**PLANNED UNIT DEVELOPMENT
& SUBDIVISION STAFF REPORT****Date: February 21, 2008****DEVELOPMENT NAME**

MFP Commercial Park Subdivision

Planned Unit Development Approval to allow three
building on a single building site, and Subdivision Approval to create a one legal lot from four
metes and bounds parcels.

SITE PLAN

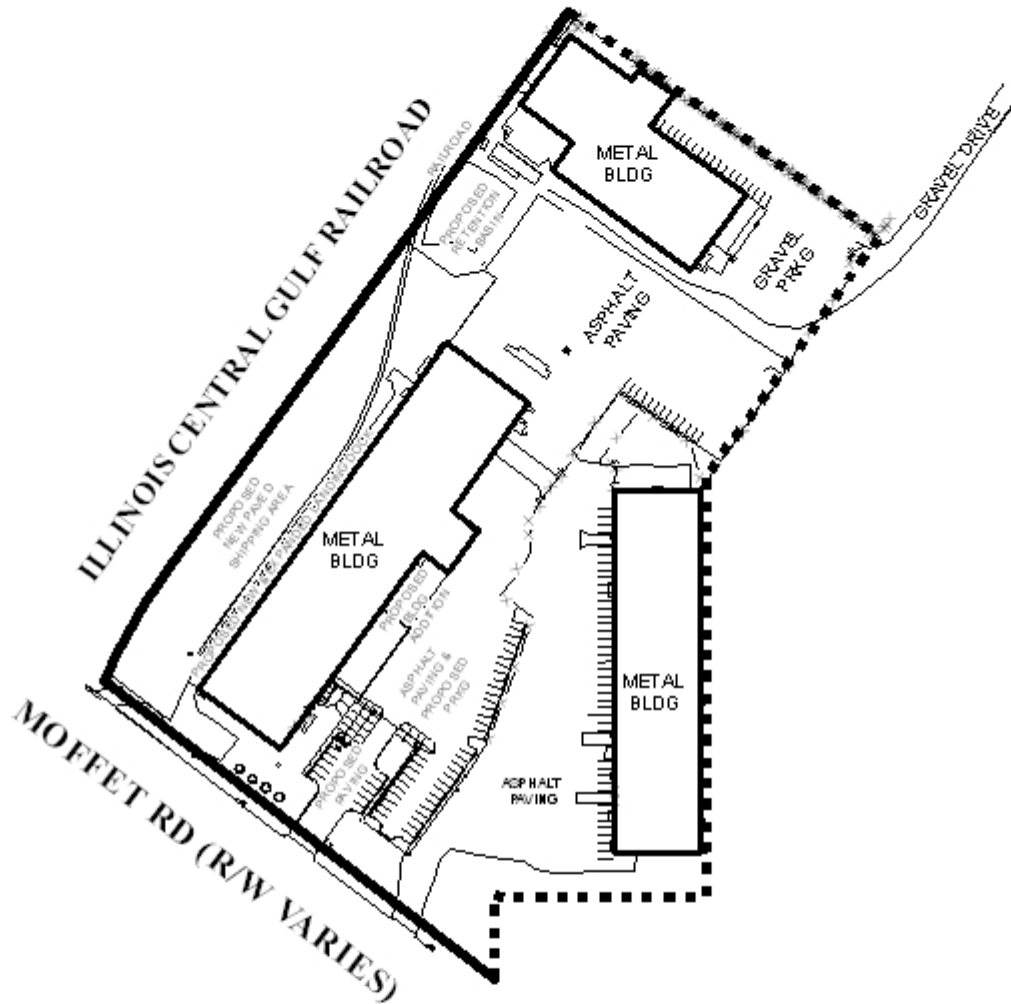
The existing PUD site contains unmarked, paved parking serving three existing warehouse/storage buildings. Information was provided regarding the square footage of each building, the north building (32,518 square feet), the western building (62,500 square feet), and the eastern building (42,716 square feet). It should be noted that the only proposed addition is to the west building, a proposed 3,288 square foot addition.

The proposed new parking area proposed (54 parking spaces) will be accessed via one, two-way drive from Moffett Road, and existing parking area (69 parking spaces) by either the two-way entrance via Crichton Street or the easternmost curb cut from Moffett Road. It should be noted that the existing westernmost drive from Moffett Road should be closed due to no vehicular access would be needed to this area of the development.

No dumpster is depicted on the site plan. If a dumpster is proposed, it should be depicted on the site plan, or a statement should be provided indicating that no dumpster will be included as part of the development.

The 25-foot minimum building setback line from all street frontages, required in Section V.D.9. of the Subdivision Regulations, is not shown for the subdivision, but would be required on the final plat, if approved.

- 1) the placement of the 25-foot minimum building setback lines along all road frontages;

- 2) the placement of a note on the Final Plat stating the development is limited to two curb cuts, along Moffett Road, and the existing curb cut to Crichton Street with the design, size and location to be approved by Traffic Engineering and ALDOT and conform to AASHTO standards;
- 3) the illustration of the calculations regarding the number of parking spaces required per Section 64-6.6, of the Zoning Ordinance;
- 4) the illustration of the dumpster on the site plan, or a statement that no dumpster is proposed for this development;
- 5) the construction of sidewalks along Moffett Road or the submission of a sidewalk waiver; and
- 6) the submission of a revised PUD site plan depicting the conditions of approval, prior to the signing of the Final Plat.
